# TN-USB-FX-01 Manual Update

## Driver Installation Note - Change “Speed and Duplex” to “100 Mbps Full Duplex”

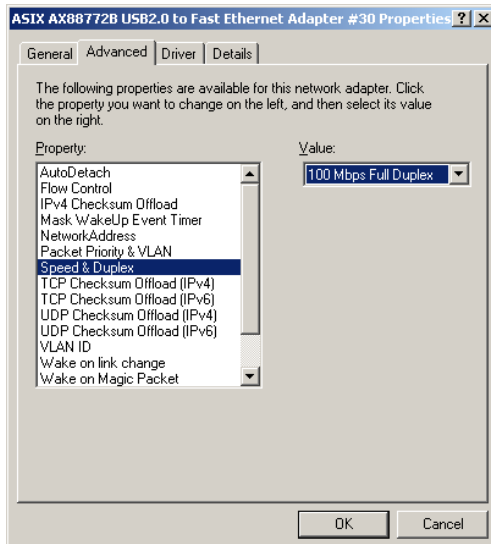
After you successfully install the driver, the TN-USB-FX-01 will work properly for a short time. To ensure continual operation, you must change the “Speed and Duplex Property Value” as described below.

1. In Windows, navigate to the Start > Settings > Control Panel > System > Device Manager > Network Adapters menu path.

2. Select and right click the “ASIX AX88772B USB to Fast Ethernet Adapter” (the name of the chipset / manufacturer). The General tab displays the message “Windows has stopped this device because it has reported problems.(Code 43)”.
3. Select “Properties” and then select the “Advanced” tab.

4. At the “Speed and Duplex Property Value” dropdown, change the Ethernet link speed from “Auto Negotiation” to “100 Mbps Full Duplex”.
5. Click the **OK** button.
6. Unplug and replug the TN-USB-FX-01. The device will now run properly.
